PROJECT: Town of Lexington
CWSRF Project. No. CS010886-02
KG Project #22-0032

ADDENDUM NO. Four (4)

DATE: June 14, 2024

PROPOSED IMPROVEMENTS PLAN
CWSRF/ARPA SEWER SYSTEM IMPROVEMENTS
TOWN OF LEXINGTON
LAUDERDALE COUNTY
ALABAMA

SHEET NO.
6

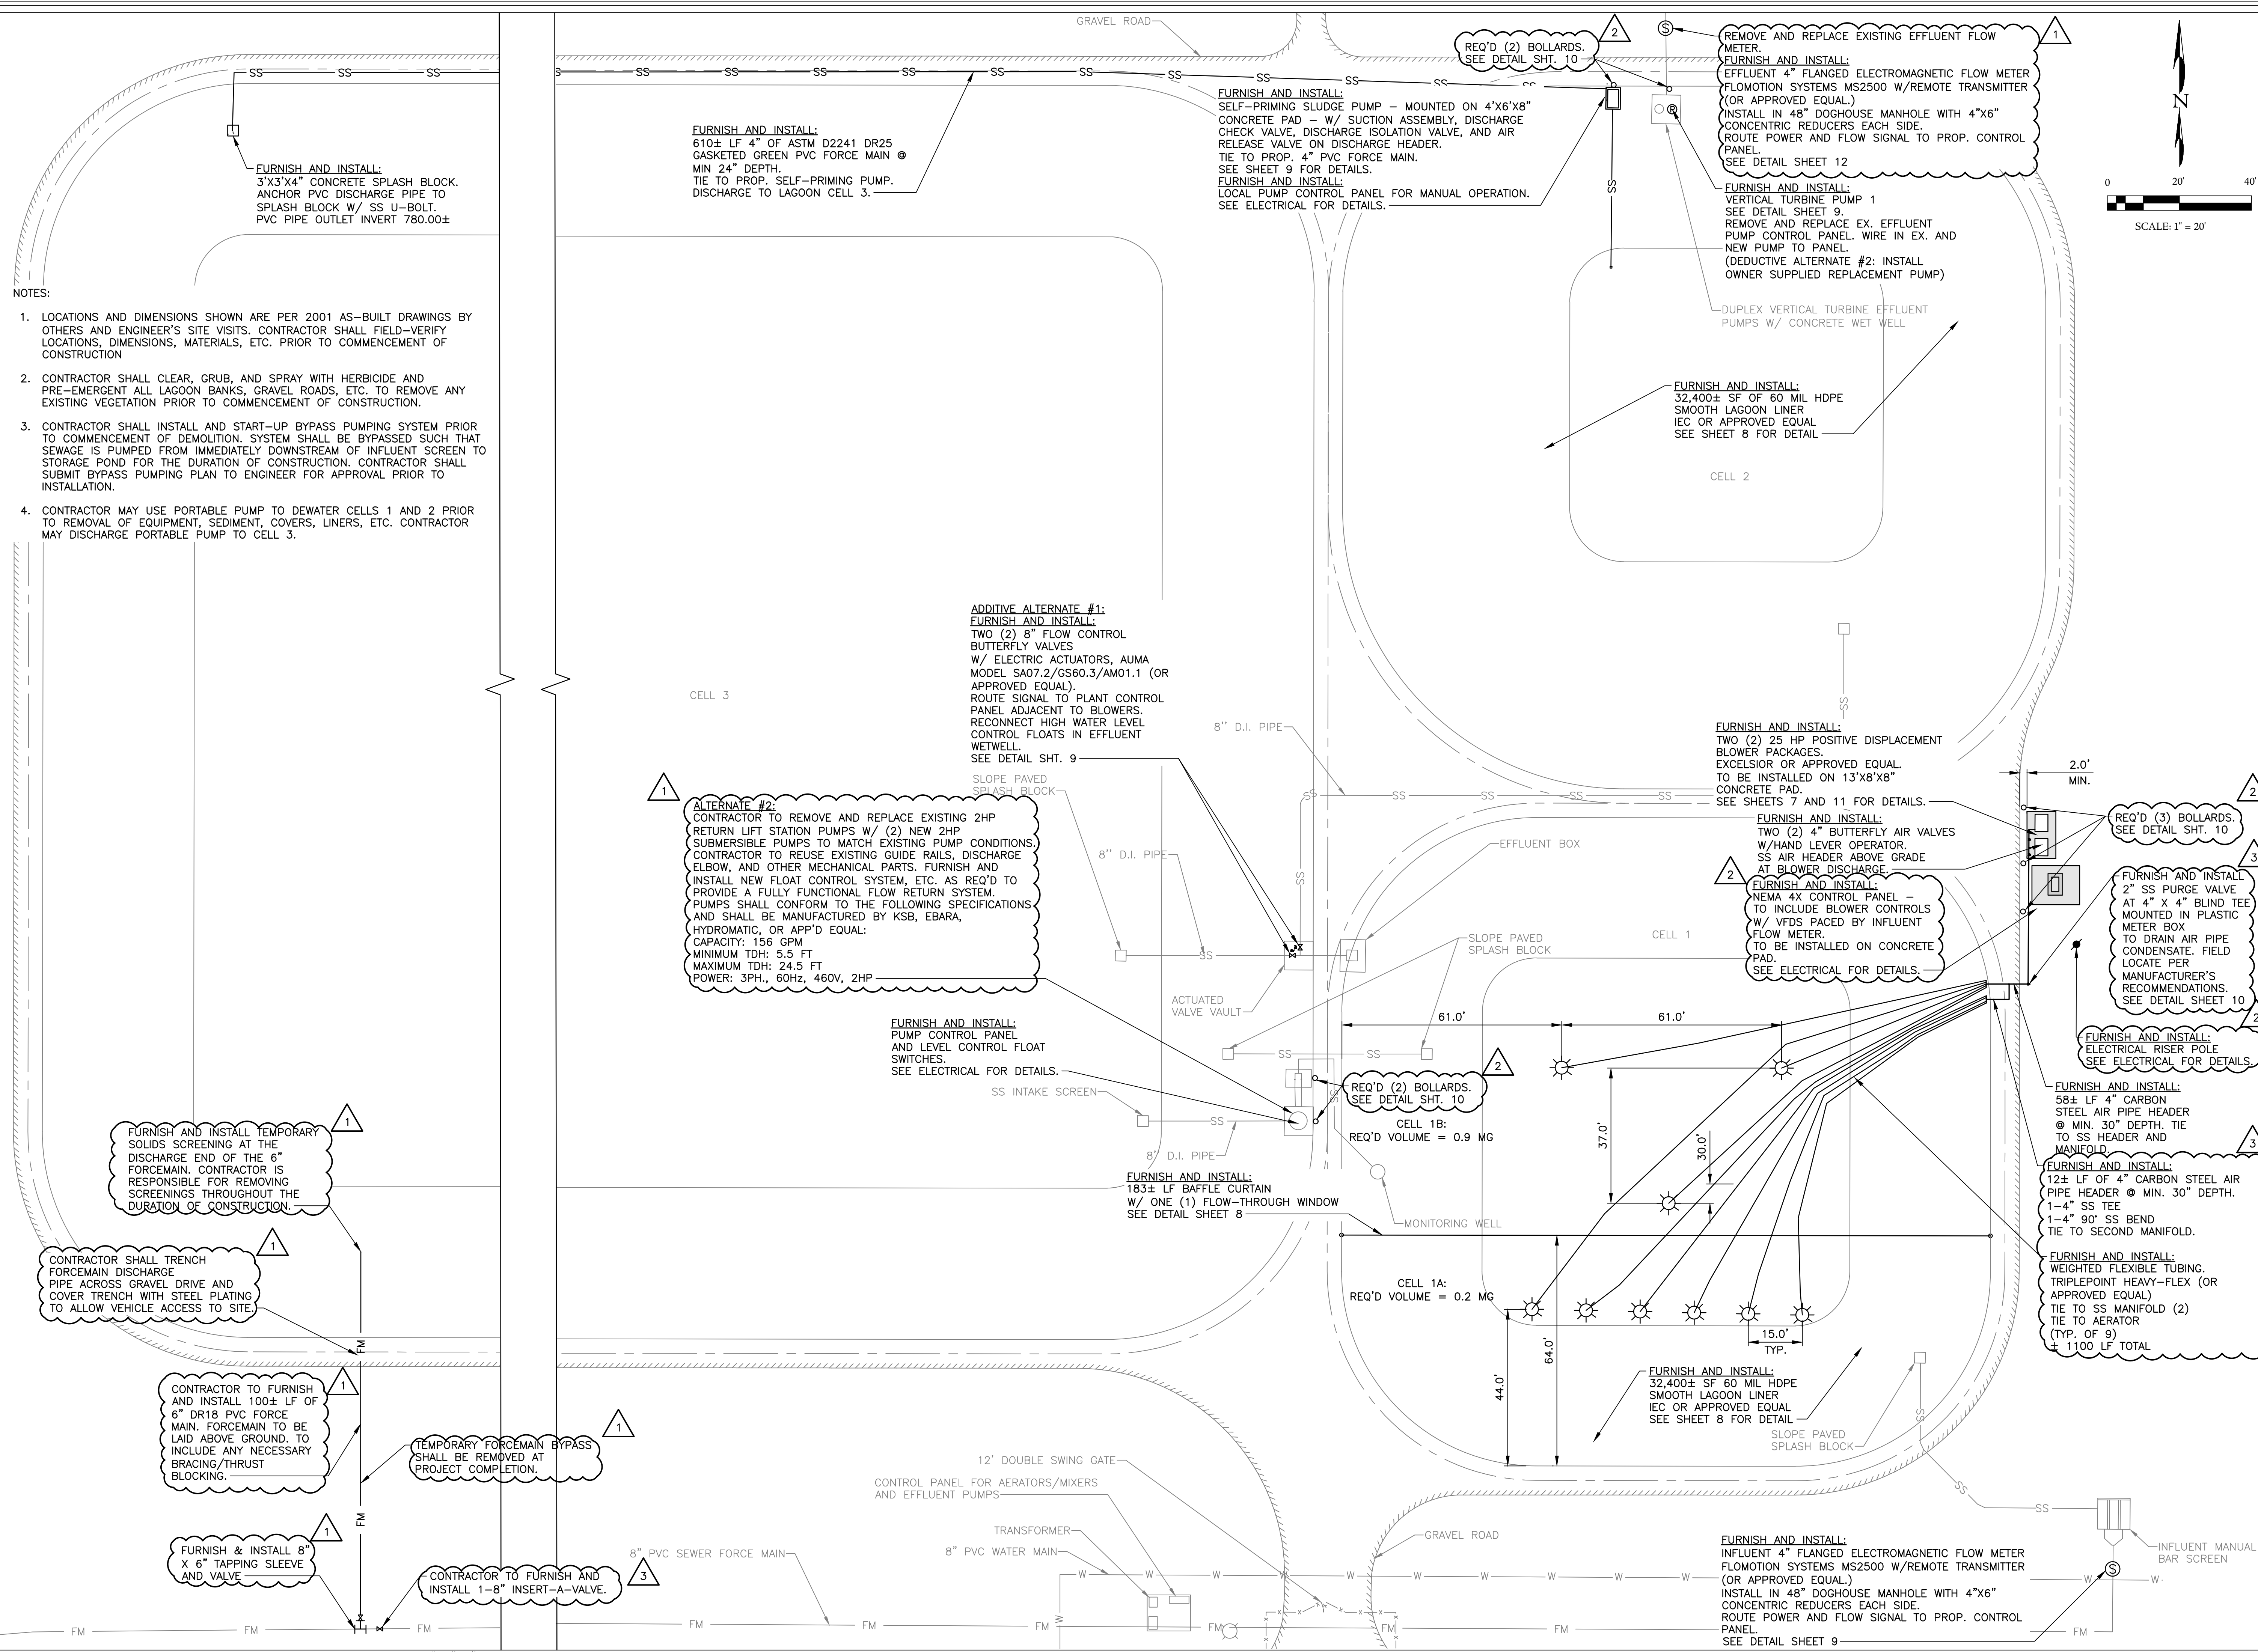
Q: Can influent plug valve be removed since bypass system and isolation valve has been moved upstream of headworks?

1. Remove Sheet 6 from the contract documents and replace with Sheet 6 attached hereto.

A: Yes, please see revised Plan Sheet 6 attached hereto.
